ROSA Inc.
Ramapo Organized for Sustainability and a Safe Aquifer
PO Box 712
Pomona, NY 10970

RE: Comments regarding Patrick Farm NYS DEC Application

Exhibit A

**Culvert #6 under Road D +Culvert #7under Road F - Crossing over ACOE
WOUS unnamed tributary of Mahwah as shown in Cut and Fill DEIS Figure**

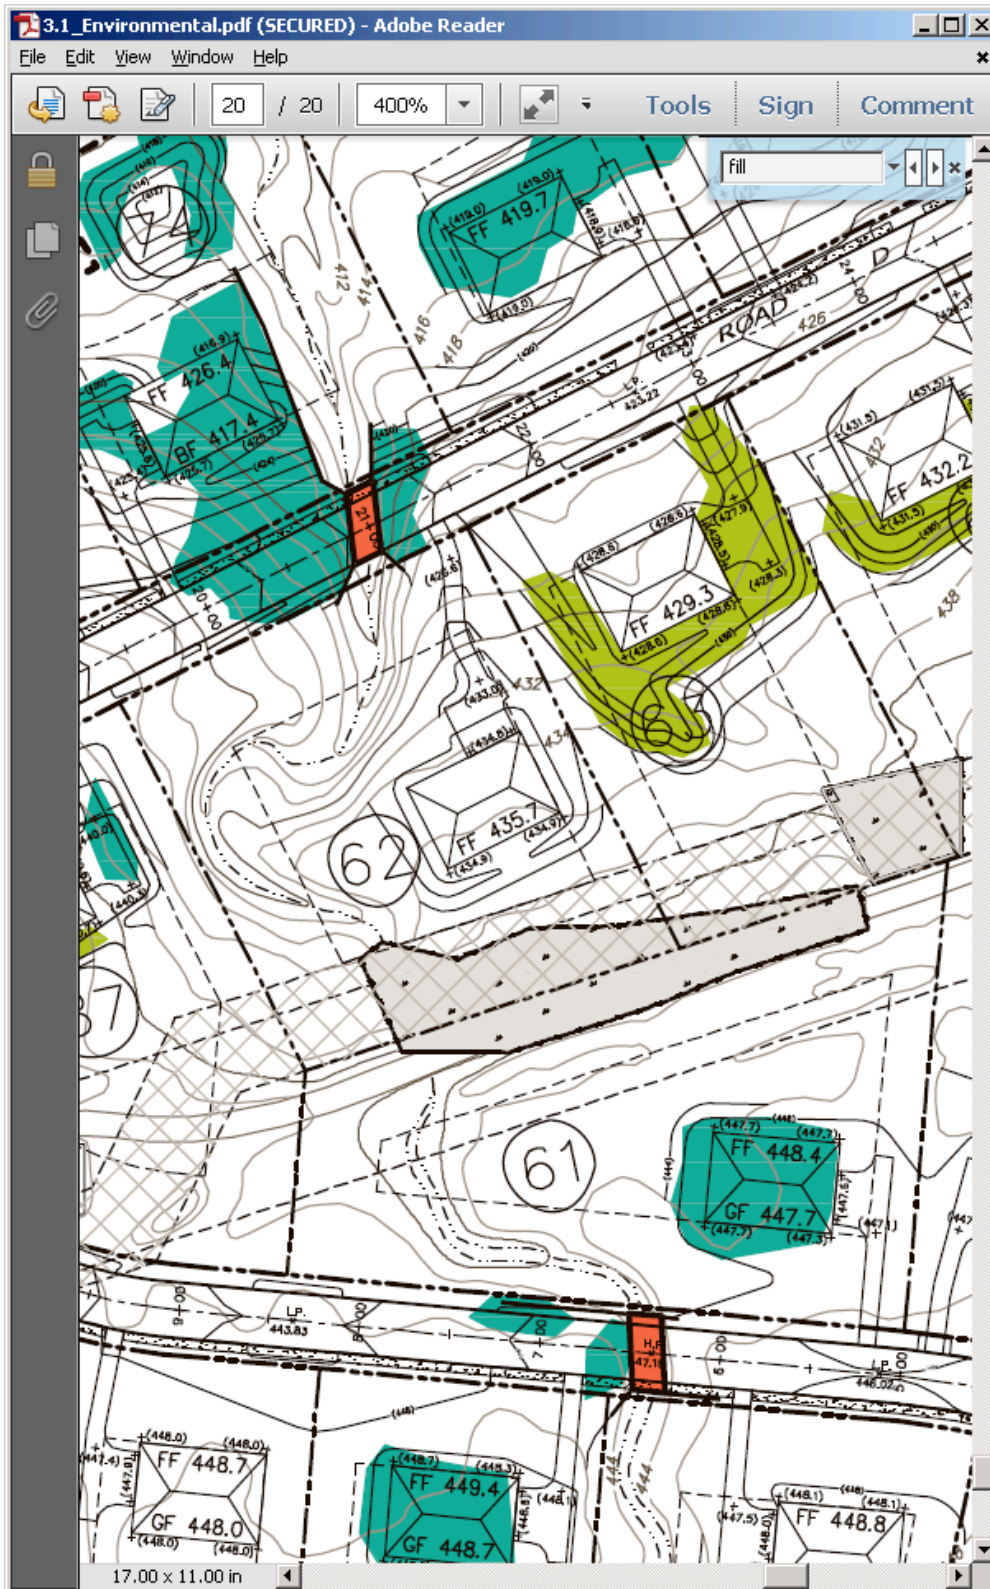
These two streams might not be under DEC jurisdiction but they were highlighted on the 02/03/2010 map and these two stream crossings still exist on the current plans. This is still a SEQRA issue.

Homes Sandwiched between Columbia Gas Easement and DEC Wetland

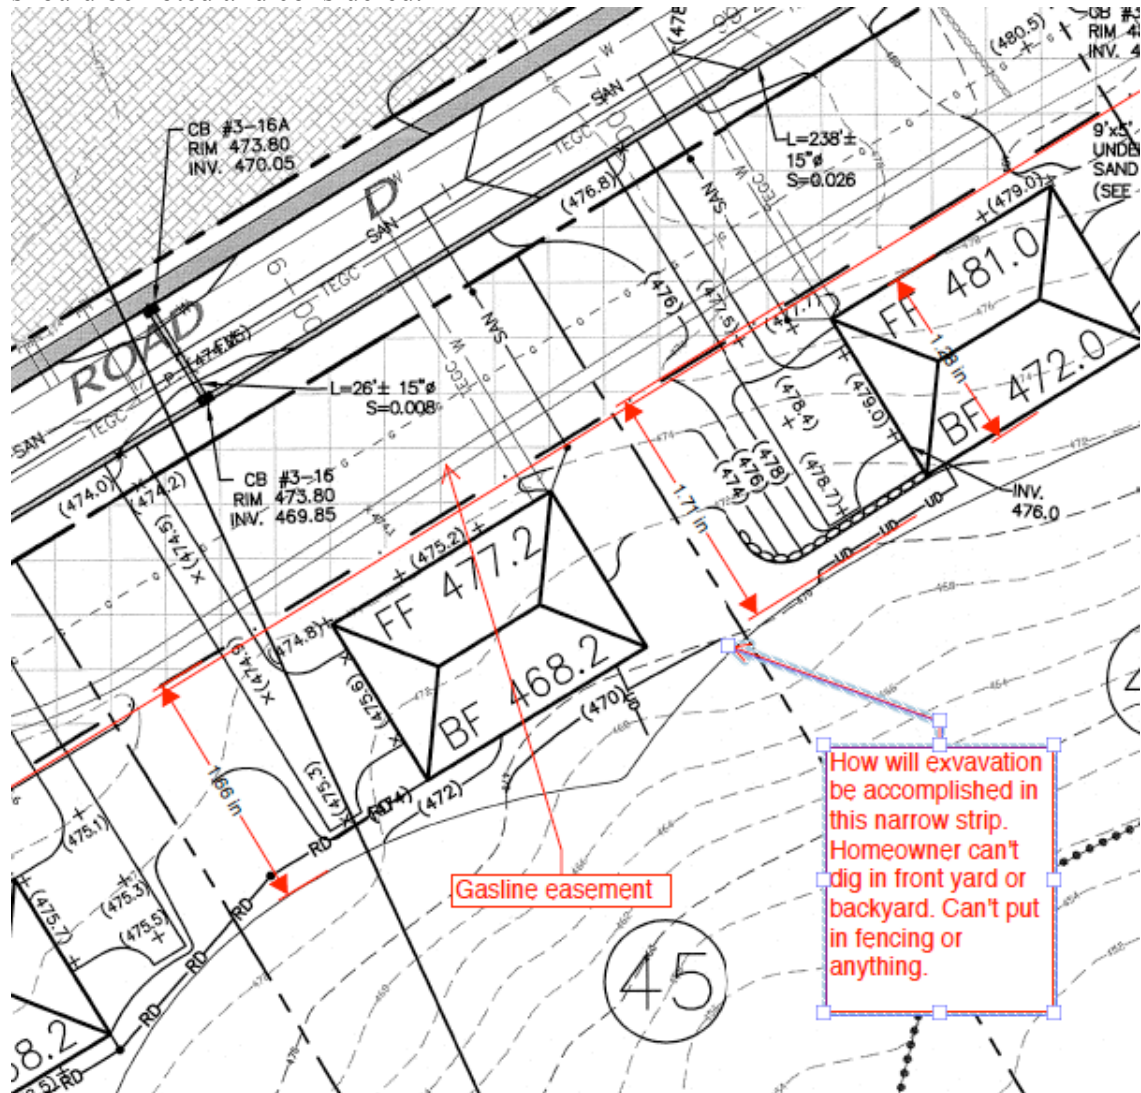
Homes 44, 45, 46 and 47 are sandwiched between a high-pressure gas pipeline and DEC wetland. For lots 45 and 46 the distance between the two easements is 70-80'. All excavation for

homes 50' deep need to take place within this narrow strip leading to possible infringements that should be noted and considered.

Water Quality Basin #3

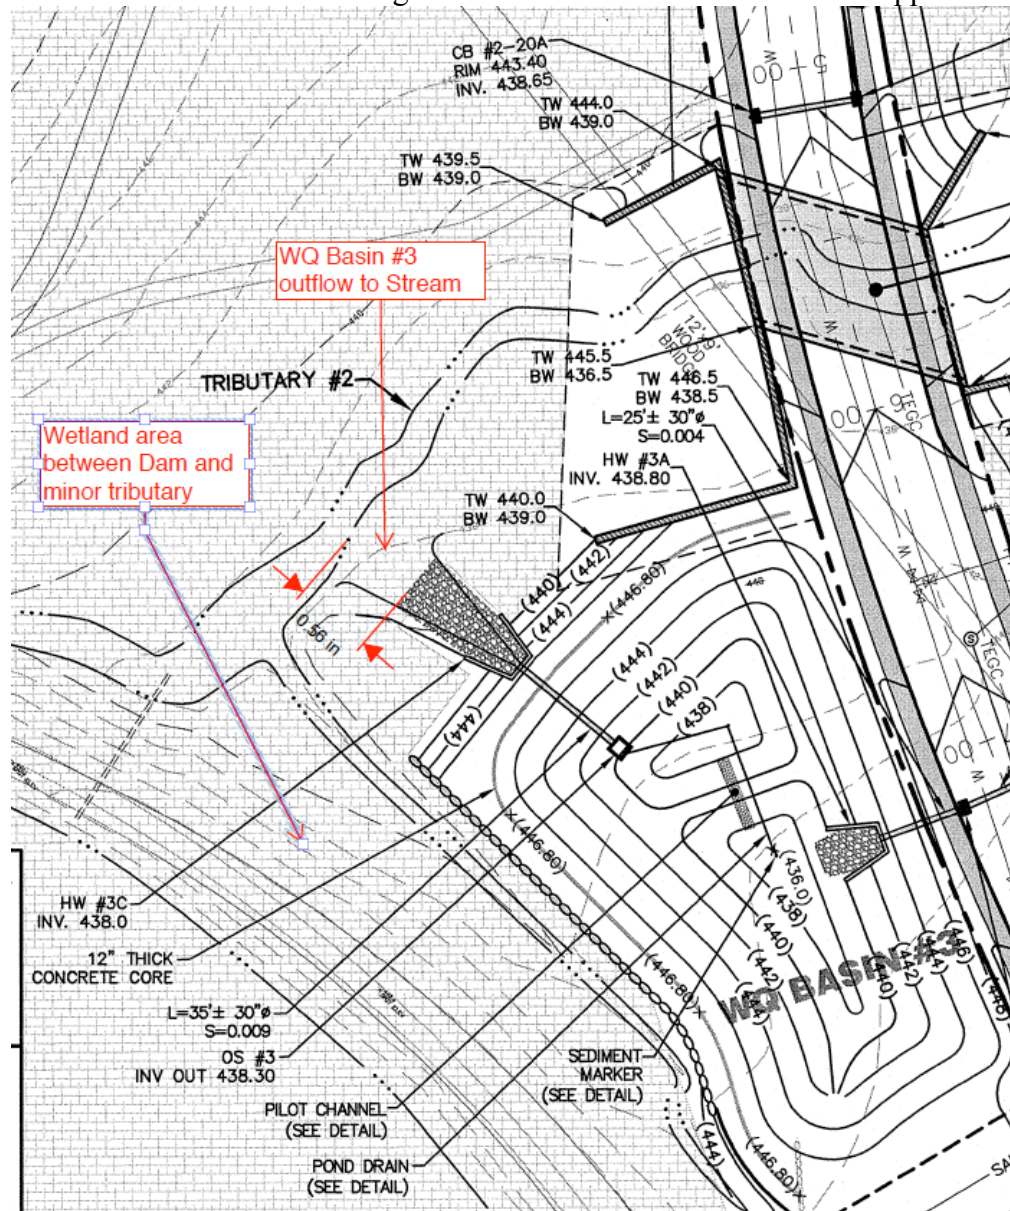
Shown on subdivision drawing #14 drains to class B Stream within approximately 25' of stream.

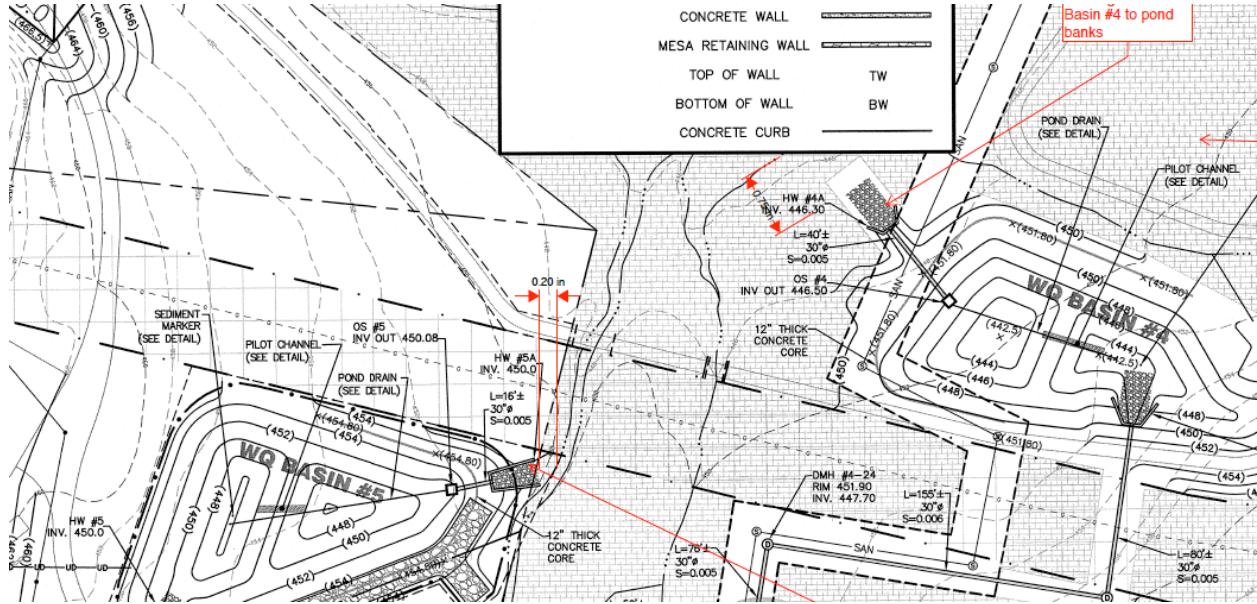
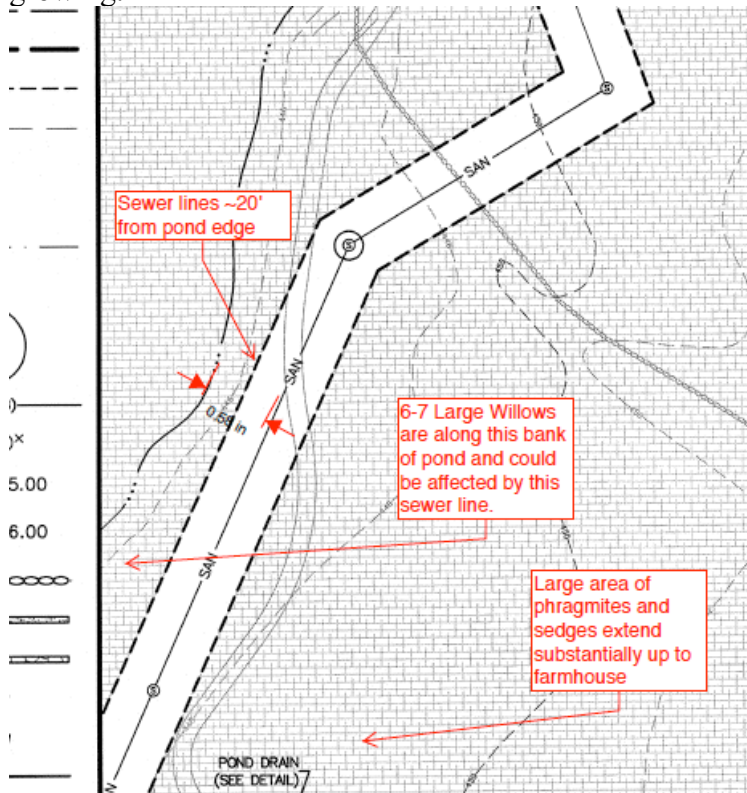
Water Quality Basin #4 drains to wetland around pond <50' from pond edge; note obscured by legend on drawing and Water Quality Basin #5 drains to tributary <10

The following the extract is from drawing #18 of the final subdivision plan.

Directly above this area shown on drawing #18 you can see the sewer line crossing through the banks of the pond within 20' of the pond edge where there are willow trees and phragmites growing.

Water Quality Basin #6 and #7 Drains into ACOE A (Drawing #13 of subdivision)

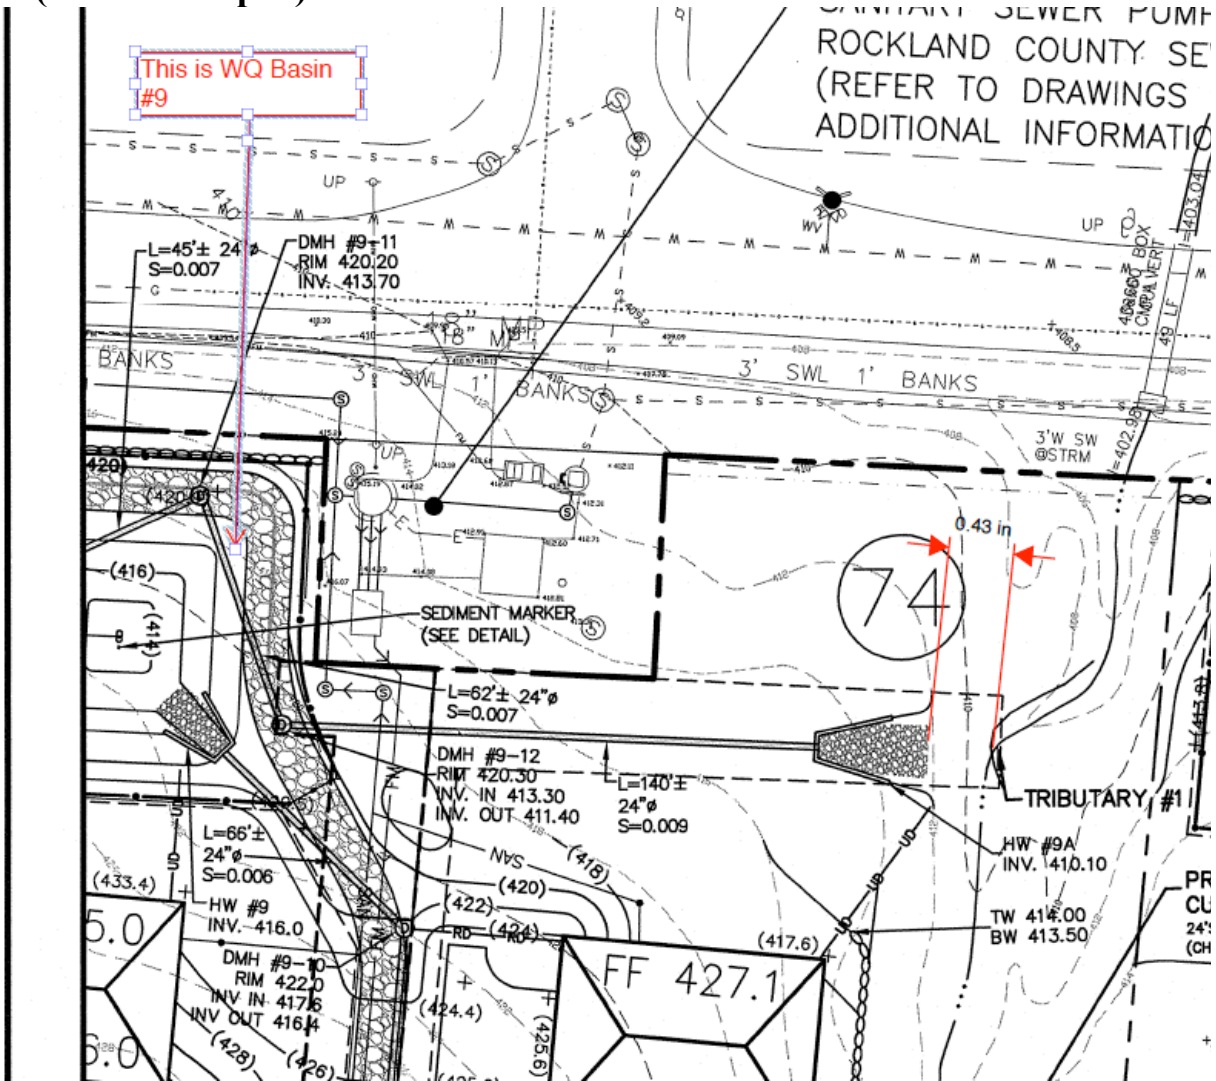
Taking roof drainage and routing it away from wetlands will starve wetlands.

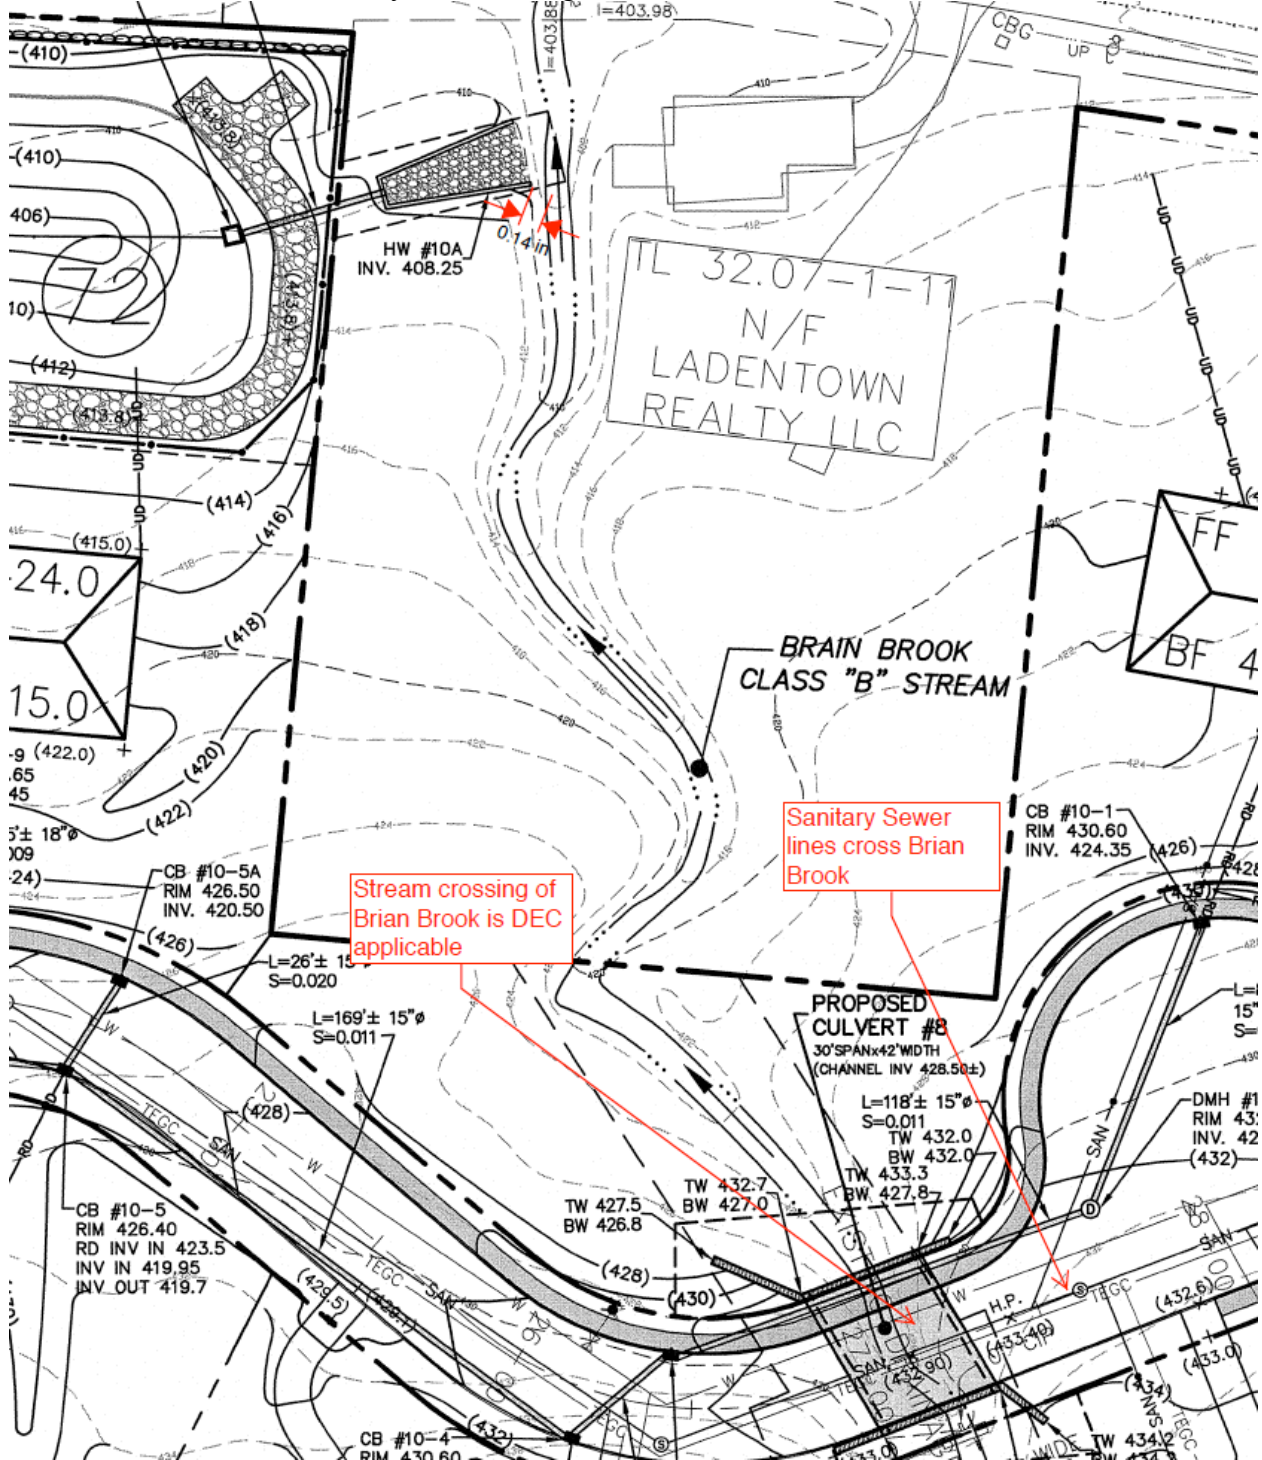
Water Quality Basin #8
Water Quality Basin #9 drain to unnamed tributary #1 to Mahwah River
<20' (subdivision p16)

Water Quality Basin #10 shown on subdivision p16 drain to class B Brian Brook off site. ~10' (subdivision p16)

The following extract from final subdivision drawing #16 shows the culvert over the Class B Stream Brian Brook, a sanitary line crossing the stream and the outflow from WQ Basin #10

Walkway South and South East of Pond

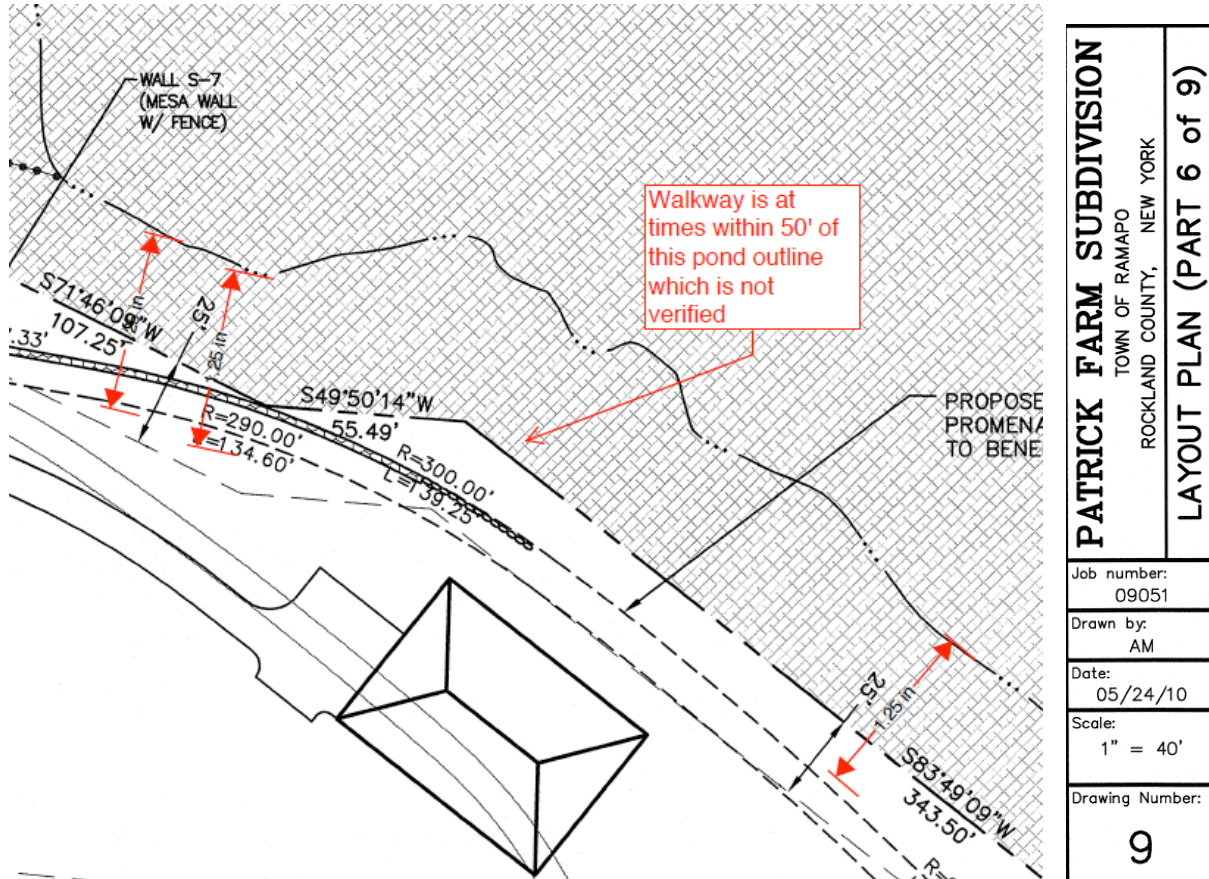
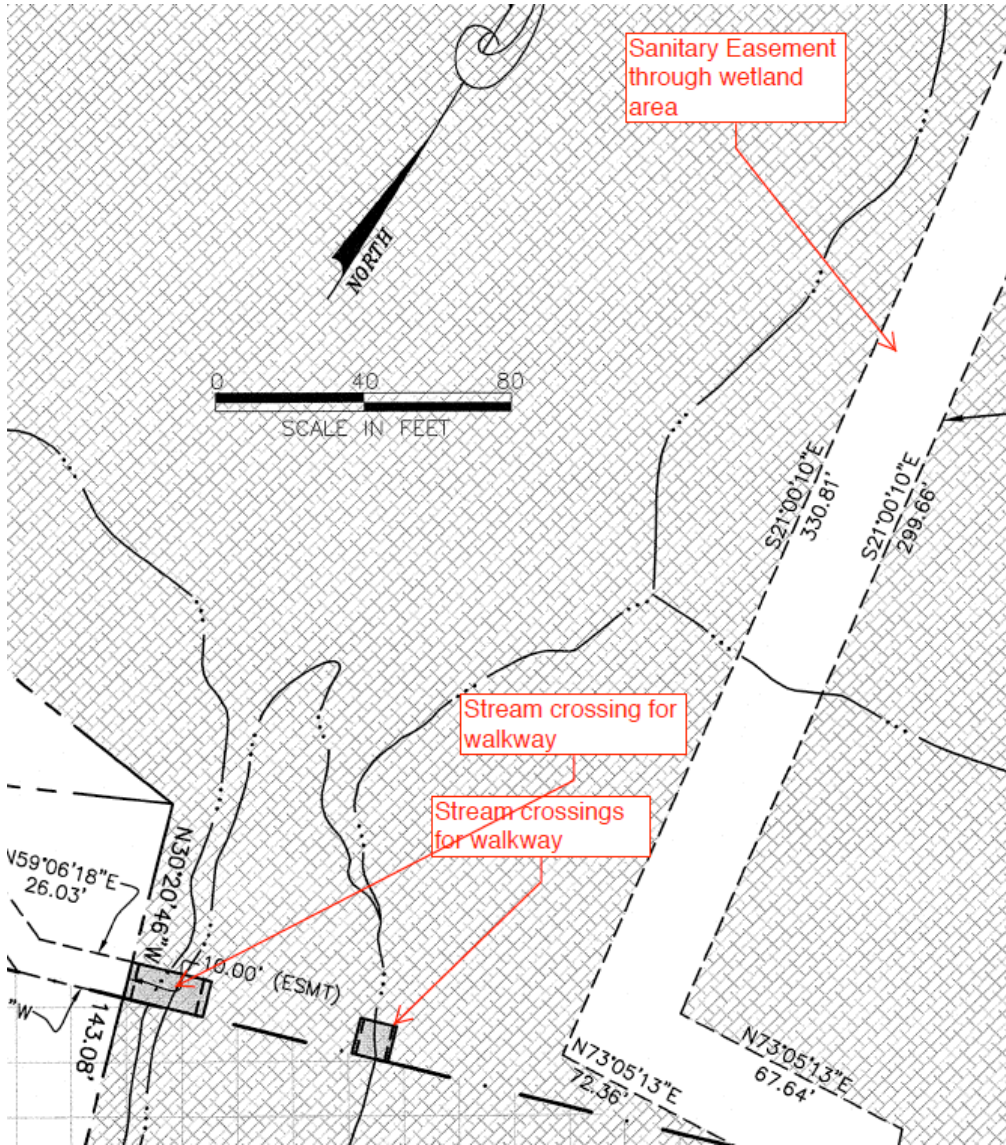
The area where the applicant proposes a walkway is a key area of dispute regarding wetlands and boundaries. It was noted by DEC in its letter of 2009-12-30, which discusses potential streambed disturbances.

Also from subdivision drawing #9 you can see that the walkway crosses over two tributaries to the stream in a sensitive wetland area. These crossings are not highlighted. And you can also see the sanitary easement for the sewer lines that are crossing directly through the path of the willows trees that border the east/southeast section of the pond.
